**AMENDMENT AND RESPONSE TO COMMENTS FOR THE OU4 COMPLEX SILOS
1&2 IMPLEMENTATION PLAN FOR ABOVE-GRADE DECONTAMINATION AND
DISMANTLEMENT AND AMENDMENT TO OPERABLE UNIT 3 INTEGRATED
REMEDIAL DESIGN/REMEDIAL ACTION WORK PLAN REGULATORY
MILESTONES**

**AMENDMENT #1 - OPERABLE UNIT 4 (OU4) COMPLEX SILOS 1&2
IMPLEMENTATION PLAN
FOR ABOVE GRADE DECONTAMINATION AND DISMANTLEMENT
ADDITIONAL DETAIL FOR COMPONENTS 34A, 34B AND
G-008 (SILOS 1&2 AND AWR BRIDGES)
DECONTAMINATION AND DISMANTLEMENT ACTIVITIES**

**OPERABLE UNIT 4 (OU4) COMPLEX SILOS 1&2 IMPLEMENTATION PLAN FOR
ABOVE-GRADE DECONTAMINATION AND DISMANTLEMENT
FERNALD CLOSURE PROJECT RESOLUTION TO USEPA COMMENTS**

DOCUMENT NUMBER 40900-PL-0002 (REV. 0) PCN1

FIGURE 1-1 Silos 1&2 and Associated Structures PCN1

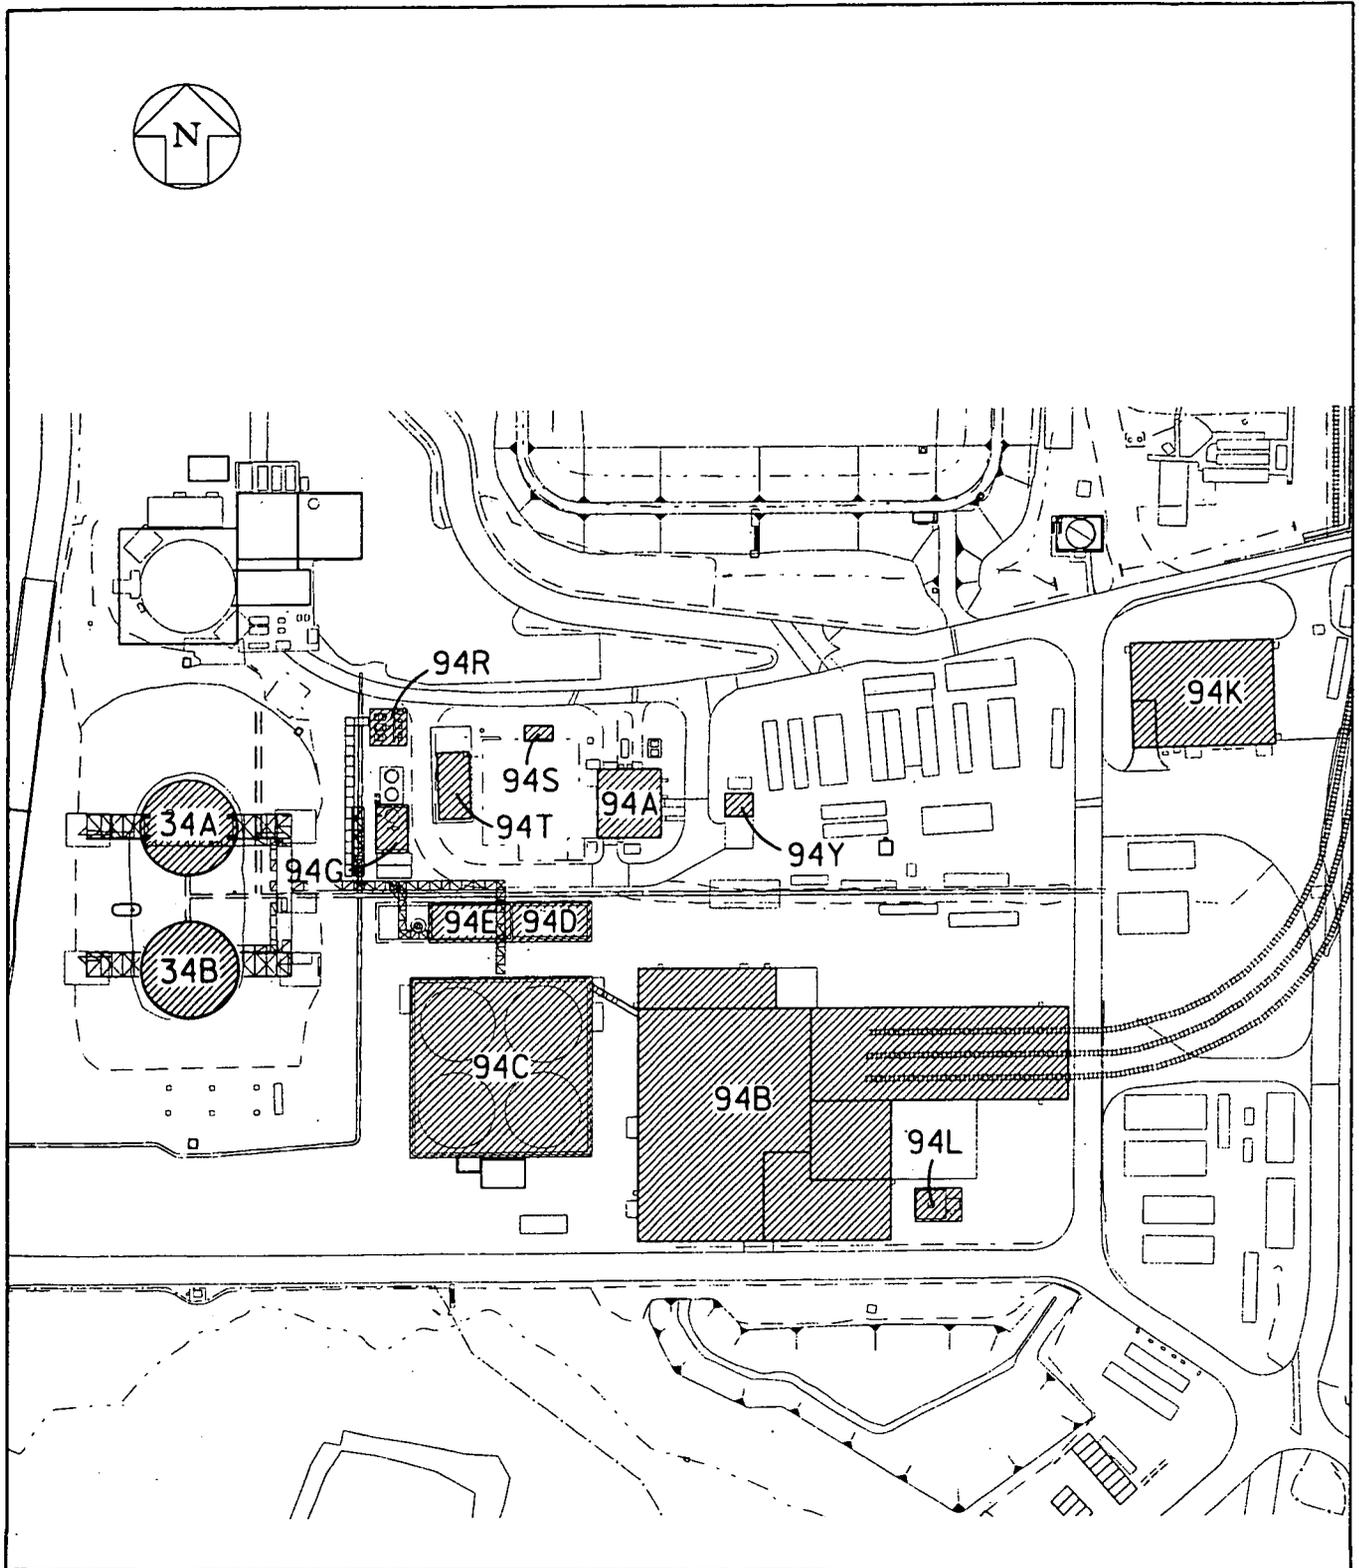
In response to Reference Letter 2, this letter also transmits the response to comments along with the OU4 Complex Silos 1&2 Implementation Plan for Above-Grade D&D Page Change Notice 1 (PCN1). Please note Figure 1-1 has been corrected to include all Silo 1&2 Components and is enclosed with PCN1. Please remove the existing OU4 Complex Silos 1&2 Implementation Plan for Above-Grade D&D pages affected by PCN1 and replace them with the enclosure.

<u>DATE</u>	<u>REVISION NO.</u>	<u>DESCRIPTION AND AUTHORITY</u>
12/15/04	Rev. 0	Issued Final Implementation Plan
2/28/05	Rev. 0, PCN1	<p>Page 4 - Revised Figure 1-1 to include Components 94T and 94Y.</p> <p>Section 2.2, Paragraph 2 – The last sentence has been changed to read: "If practical, the K-65 Trench steel piping system will be cleaned using high pressure washwater within containment to meet OSDF placement criteria."</p> <p>The following text has been added as Paragraph 3 to Section 2.3.2: "The method of pre-treat for Silo 1&2 concrete structures will be determined as a result of the concrete core sampling. Decontamination water used on the Silo 1&2 structures and their pipe bridges will be collected in onsite storage tanks with secondary containment and sampled prior to discharge to the AWWT. Bridge piping will be moved to a location where a containment can be established and decontamination performed using a high-pressure washer. After a reasonable effort is made, if the piping is unable to meet WAO inspection criteria, it will be placed in railcars for shipment to Envirocare. Decontamination activities and washwater generated during D&D of the remaining Silo 1&2 associated structures will be handled in a fashion similar to the actual Silo 1&2 concrete structures."</p> <p>The 2nd sentence of the 2nd paragraph in Section 2.3.2 has been changed to read: "This wastewater may have to be pre-treated prior to discharge to the AWWT." The 3rd sentence of the 2nd paragraph in Section 2.3.2 has been deleted.</p> <p>In Appendix A, under "Characterization Screening", the 3rd paragraph has been changed to read: "Prior to the demolition activity, core samples will be taken from the Silo 1&2 concrete structures and analyzed for heavy metals."</p>
